Parking Lamp discussion document

Use of single sided parking lamp illumination when
parking vehicles over 2 m in width

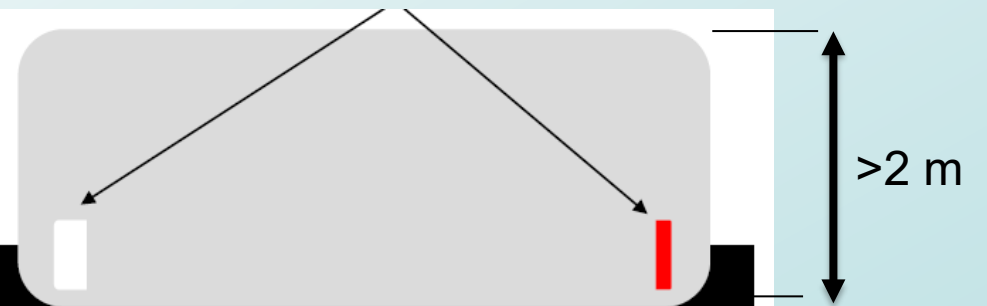
Parking lamp (low intensity) or
position lamp (higher intensity)

Allowed Condition

Parking lamp (low intensity) or
position lamp (higher intensity)

Not allowed

- Proposed amendment to allow single side illumination of the parking lamp when a vehicle is parked in a built-up area:

On motor vehicles not exceeding 6 m in length ~~and not exceeding 2 m in width~~, optional.

On all other vehicles, prohibited.
